# 162 Queens Quay East

Detailed Design

Review Stage: Detailed Design

# May 2019 DRP- Consensus comments

## LANDSCAPE PRINCIPLES INTERIM STREETSCAPE

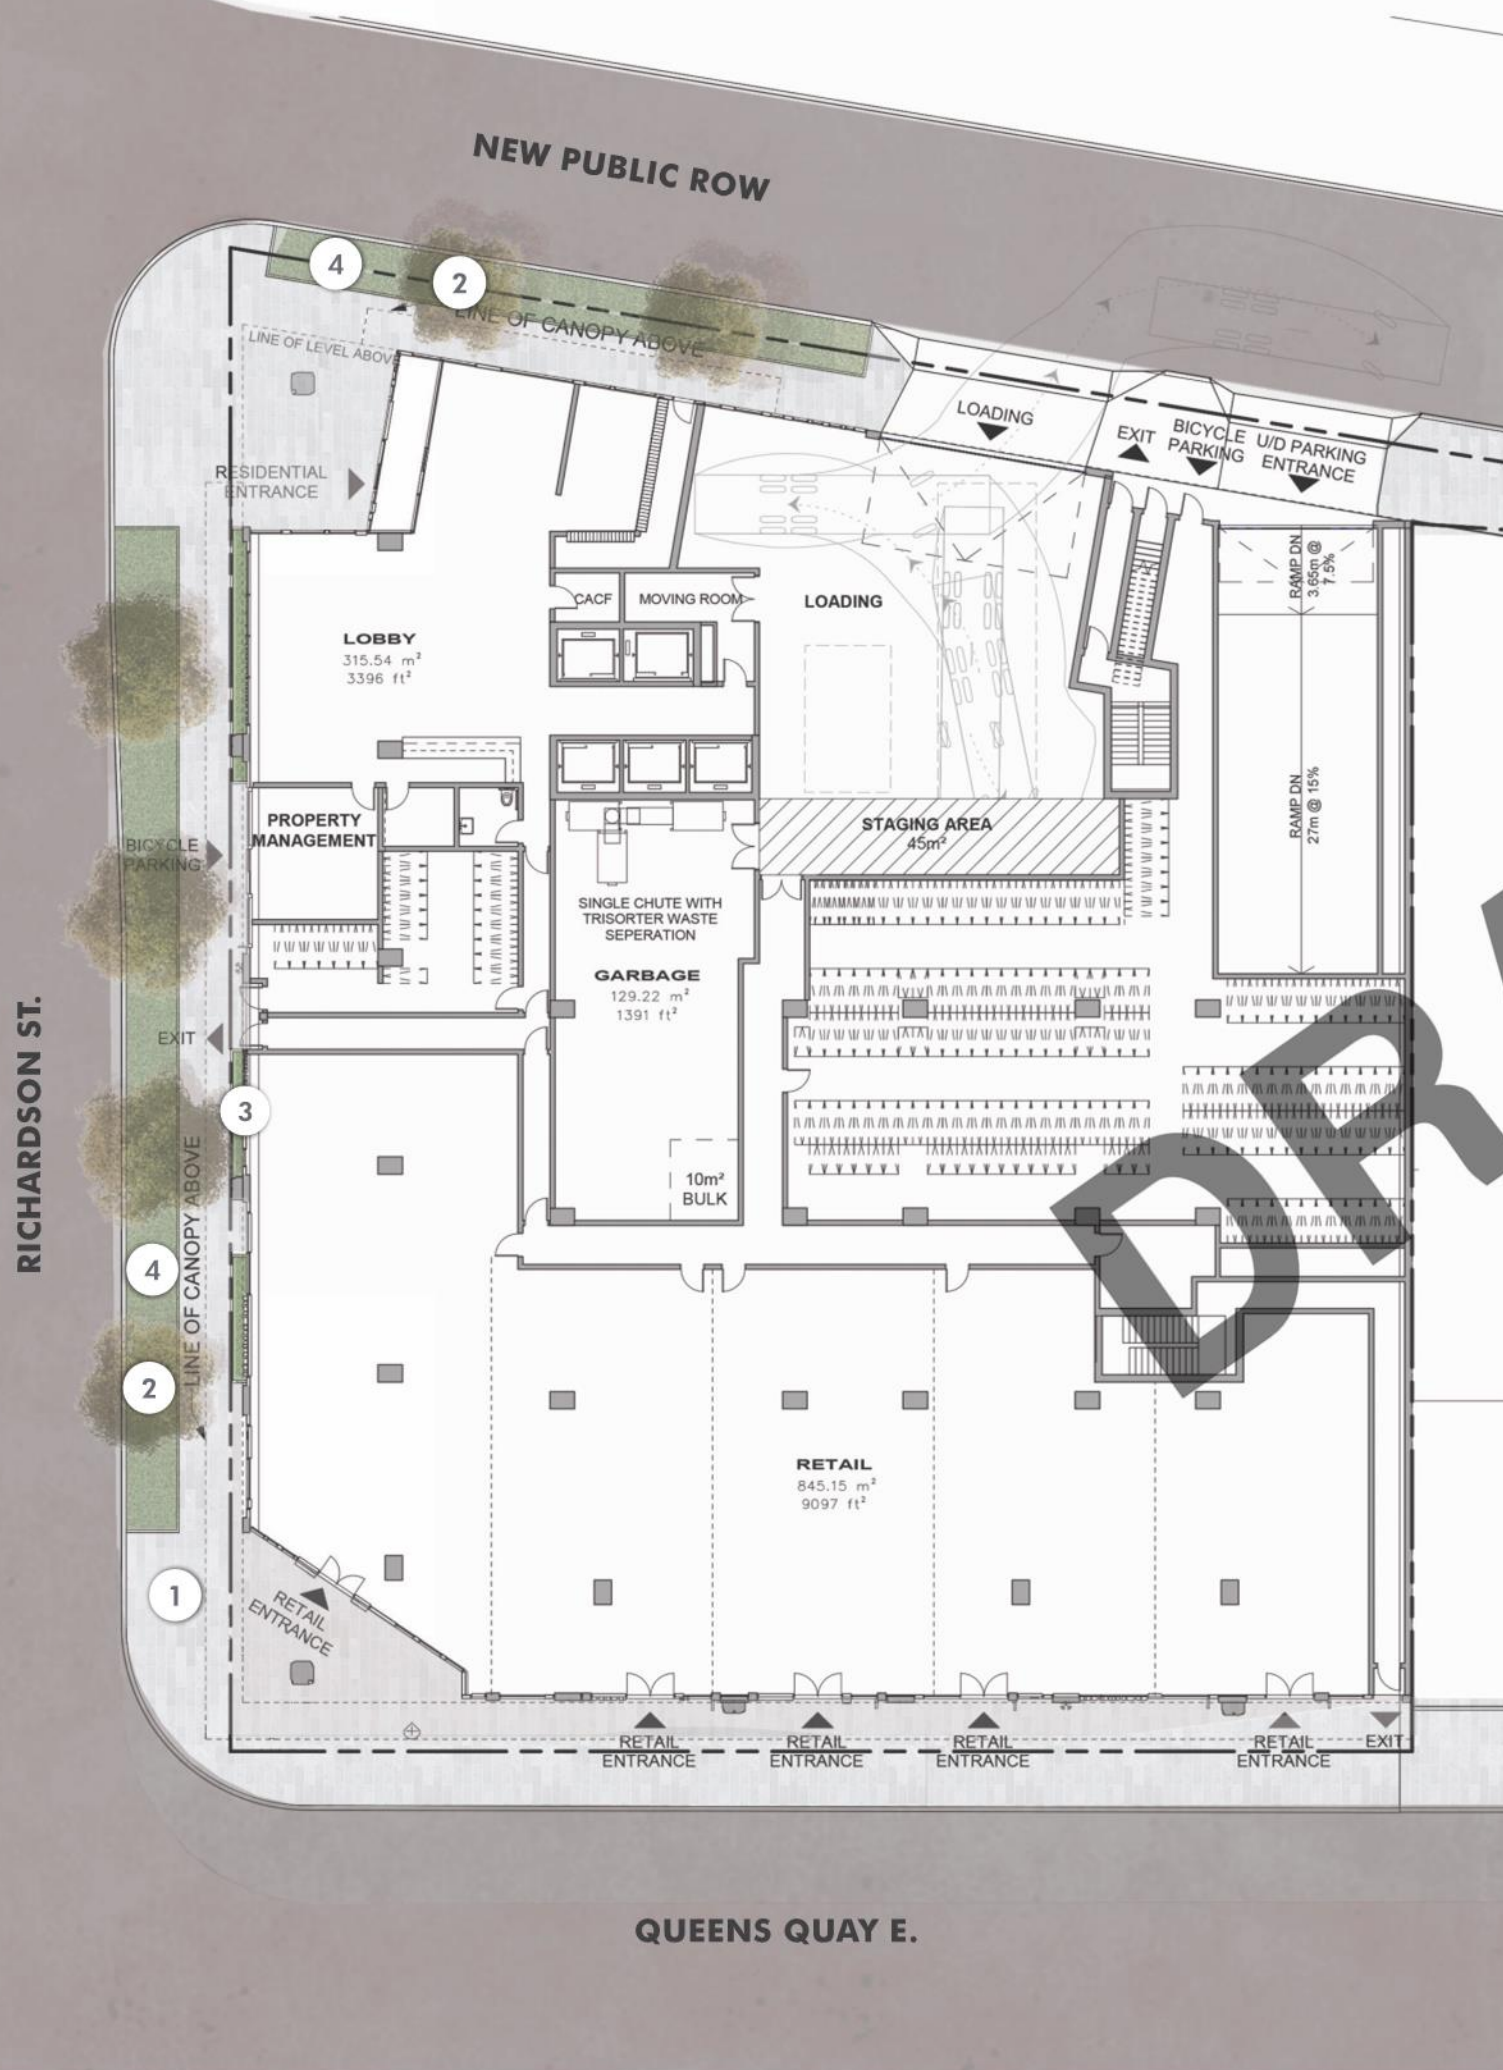
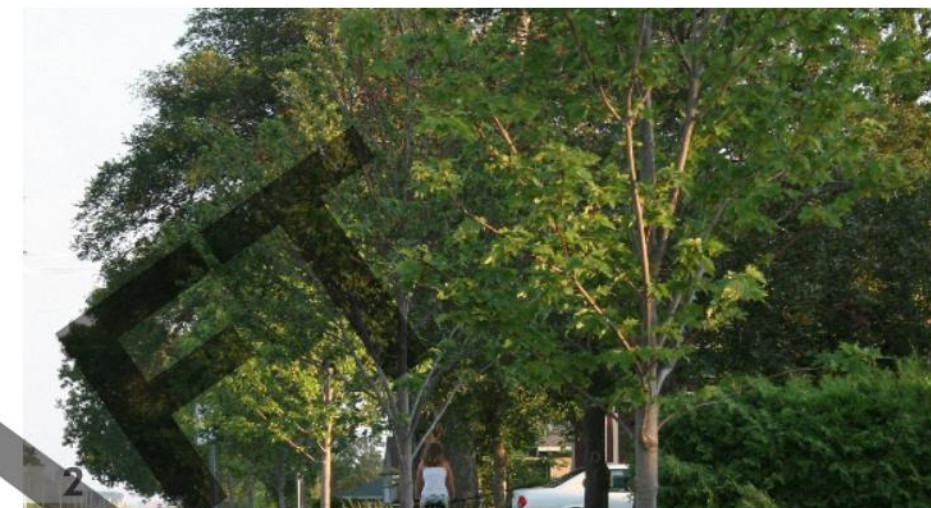
- Pull planting and benches away from the building face.

- Planting and benches have been removed from along Queens Quay East. Prior to the Queens Quay widening there will be temporary concrete pavers along Queens Quay. Along both Richardson Street and the New Public ROW, trees are proposed to be planted in raised curb beds to deter interference with species growth and survival.

## LANDSCAPE PRINCIPLES FUTURE STREETSCAPE

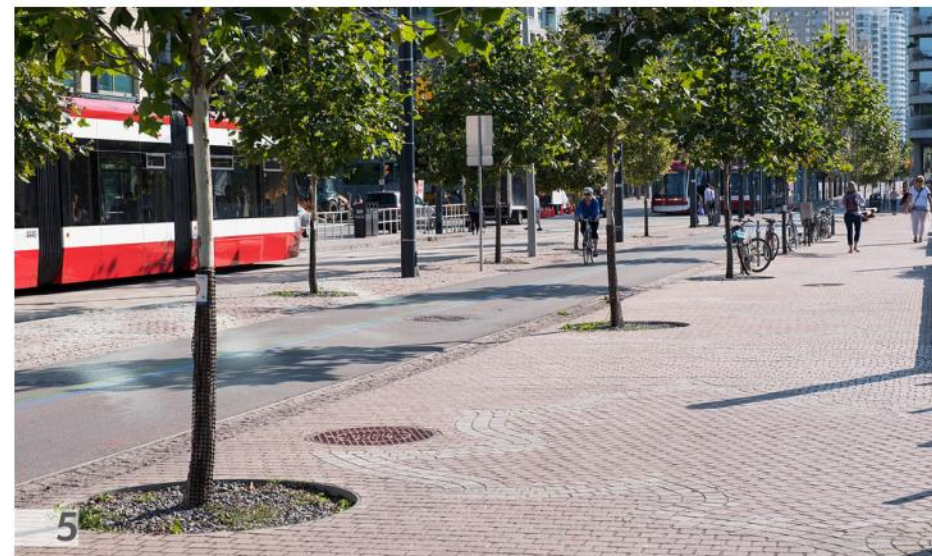
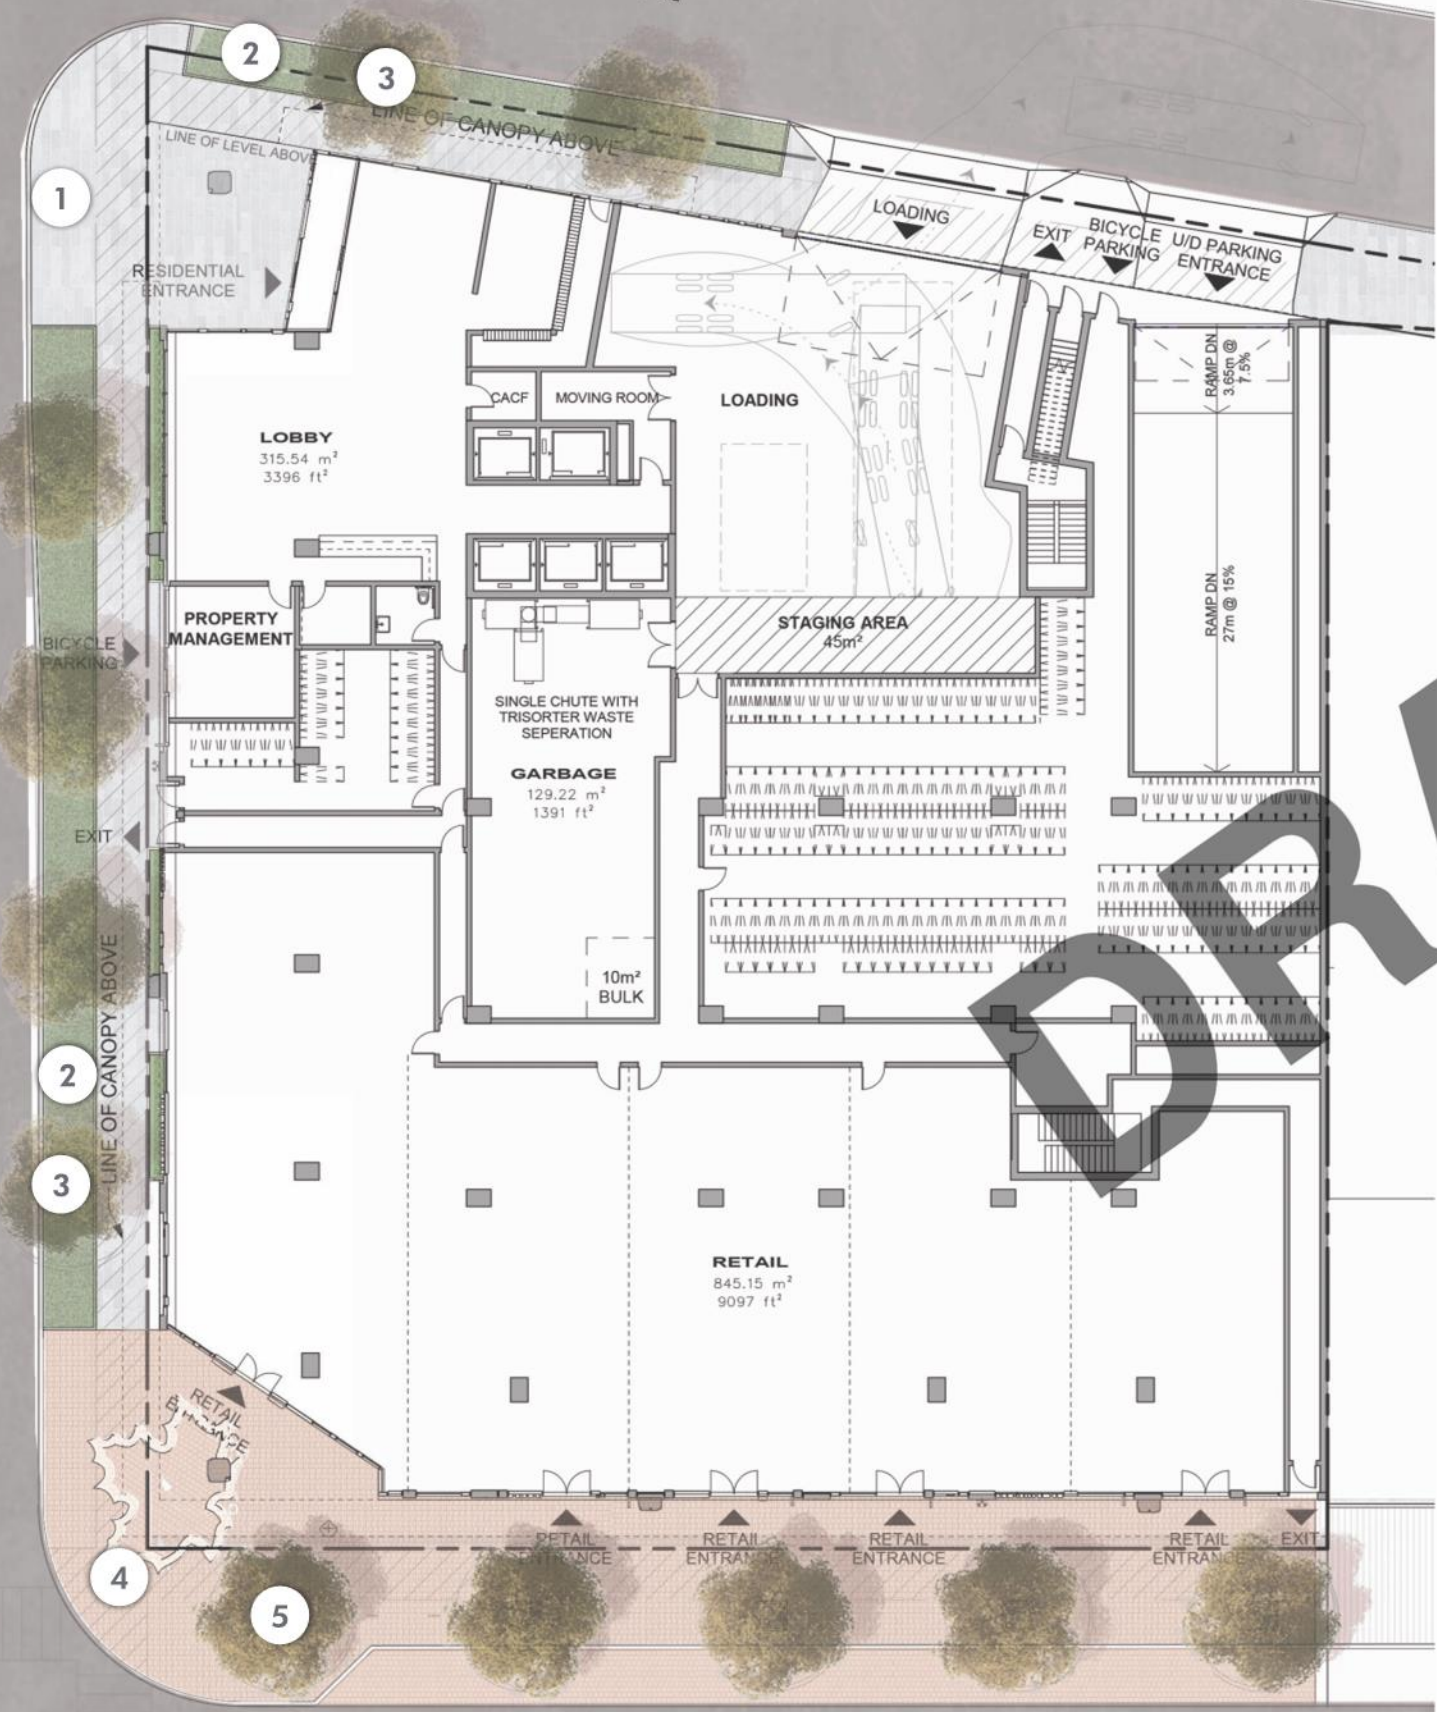
- Pull planting and benches away from the building face.

- Plating and benches have been removed from along Queens Quay East. Following Queens Quay widening, the future streetscape incorporates the standard red granite paver and signature maple leaf at the intersection of Queens Quay East and Richardson St. Along both Richardson Street and Queens Quay, trees are proposed to be planted in raised curb beds to deter interference with species growth and survival.

## QUEENS QUAY EAST

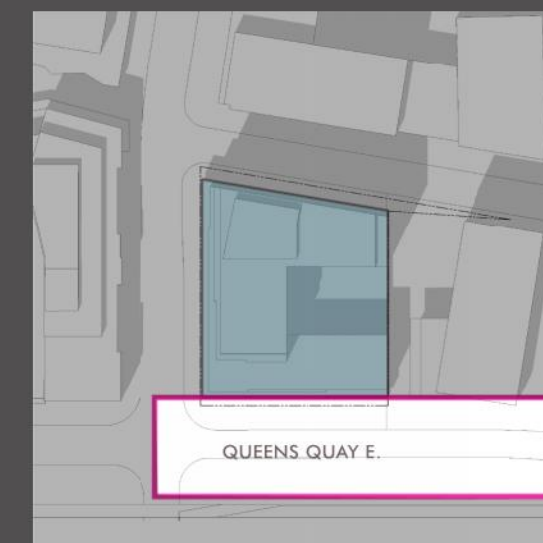
- Follow the Queens Quay Revitalization Plan for landscaping along Queens Quay

- Benches and planting along the front elevation of the building have been removed. Streetscape landscaping follows the Queens Quay Revitalization Plan and incorporates the standard circular tree pits, bicycle racks, garbage receptacles and red pavers.

## RICHARDSON ST.

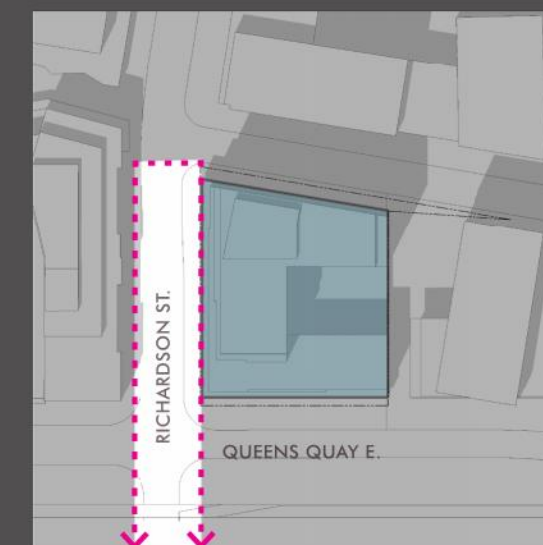
- Define the four corners of the building and take advantage of future Queens Quay Streetscape

- North-west corner is cut back and remains open creating both a visual and physical connection between Richardson and the New Public Road.
